Department of Primary Industries

Thank you for your correspondence of 21 February 2013 concerning the review of the Environmental Assessment (EA) for the proposed Modification to the Abel Coal Mine.

Specific Agricultural Impact Assessment Issues

Figure: Showing overlying land class 2 (in dark brown) and proposed bord and pillar extraction area.

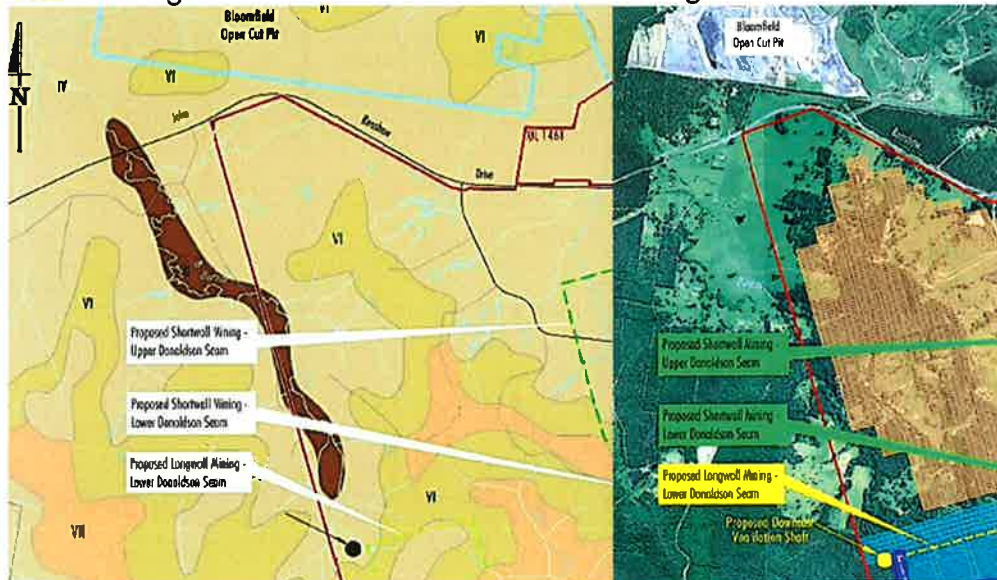
The Environmental Assessment (EA) although mentions briefly (page 46) the presence of land within the mining area of land capability class 2 suitable for continuous cropping, there is no discussion on potential risk or mitigation of subsidence if disturbed.

The EA diagrams shows that the extent of mining under AL 2 is limited.

Mining activities remain outside the identified land capability class 2 land to limit the risk of reducing the value of the agricultural resource.
